MILITARY SPECIFICATION SHEET

ADAPTER, CONNECTOR, COAXIAL, RADIO FREQUENCY, [illegible]
(WITHIN SERIES BNC), CLASS 2, "T" PLUG, [illegible]

This amendment forms a part of military specification sheet MIL-A-55339/17, dated 6 May 1975 and is approved for use by all Departments and Agencies of the Department of Defense.

* FIGURE 2, delete and substitute:

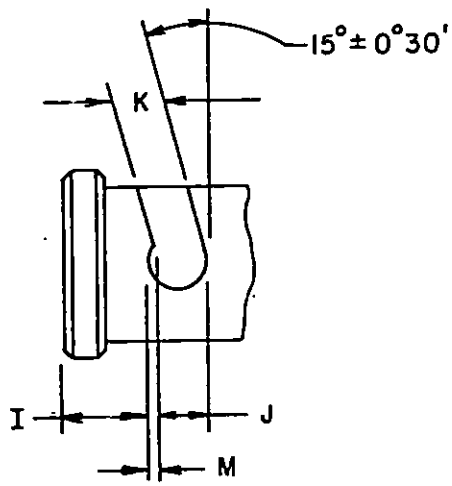
* FIGURE 2, maximum column: Add dimension E ".230 (5.84)", dimension L ".040 (1.02)", and dimension P ".228 (5.79)".
